UNITED STATES
DEPARTMENT OF THE INTERIOR
BUREAU OF LAND MANAGEMENT

SUNDRY NOTICES AND REPORTS ON WELLS
Do not use this form for proposals to drill or to re-enter an abandoned well. Use form 3160-3 (APD) for such proposals.

| 3b. Phone No. (include area code) Ph: 432.368.1352 | | 8. Well Name and No. SJ 29-5 32F |

| TYPE OF SUBMISSION | TYPE OF ACTION | | | |
|---|---|---|--|---|
| | <input type="checkbox"/> Change Plans | <input type="checkbox"/> Plug and Abandon | <input type="checkbox"/> Temporarily Abandon | Change to Original A |

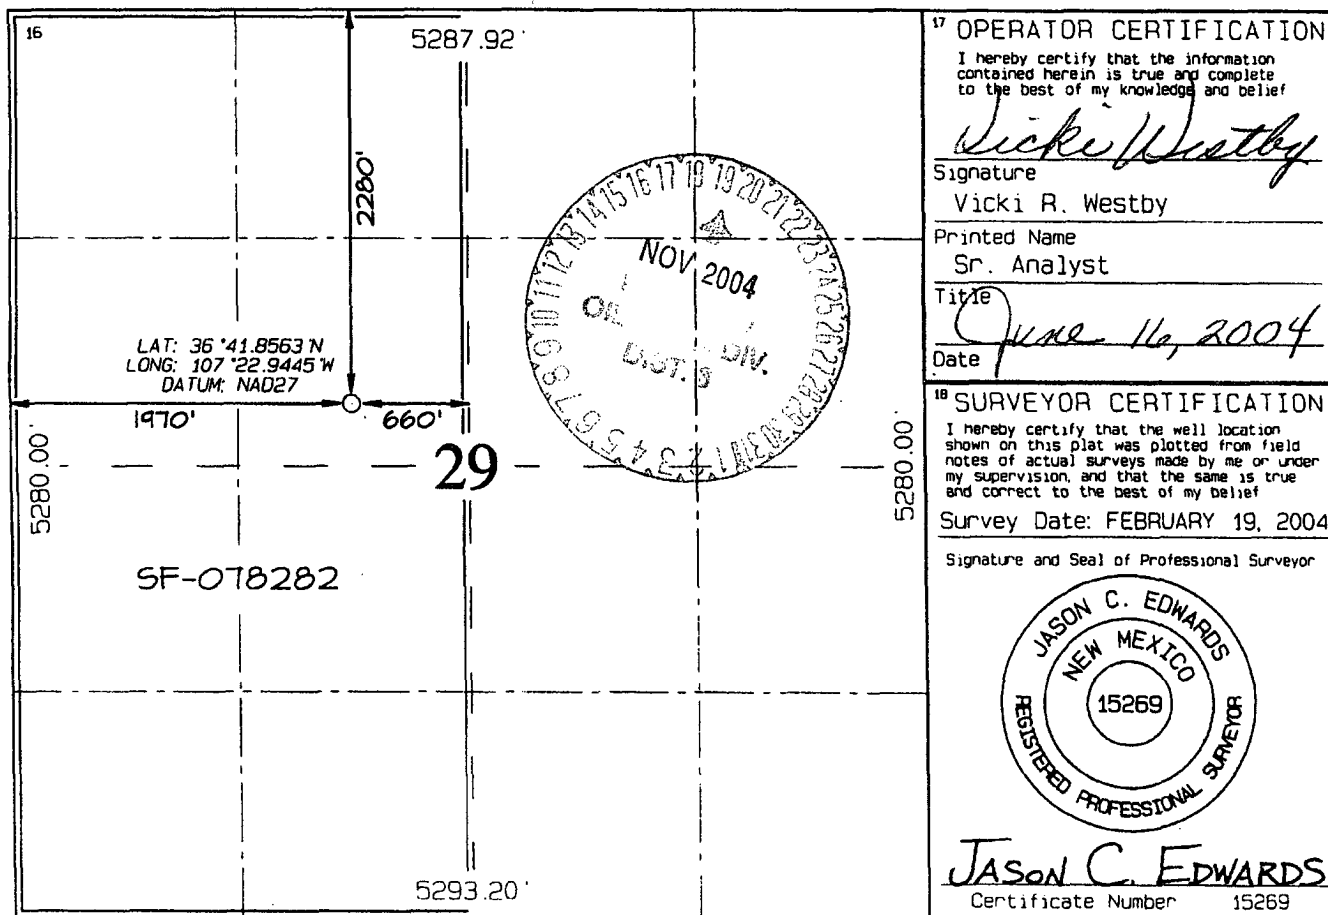
ConocoPhillips is requesting that the location of this well be changed to 2280 FNL, 1970 FWL, Section 29, T29N, R5W as shown on the attached plat.

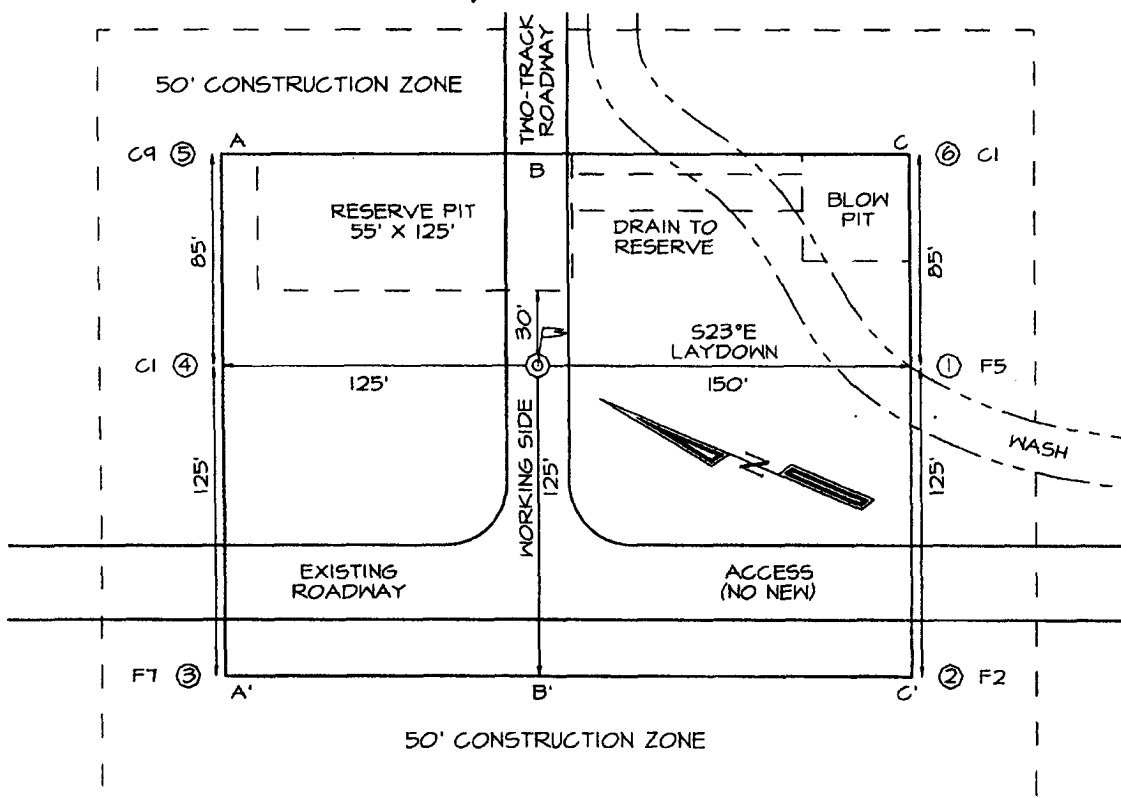
ConocoPhillips Company's Generic Pit Plan is on file at NMOCD in Aztec, NM. See the attached diagram that details the location of the pit in reference to the proposed wellhead. The drill pit will be lined. The drill pit will be closed after the well has been completed. The solids left after the water has been disposed of will be sampled and NMOCD approval will be obtained prior to closure of this pit.
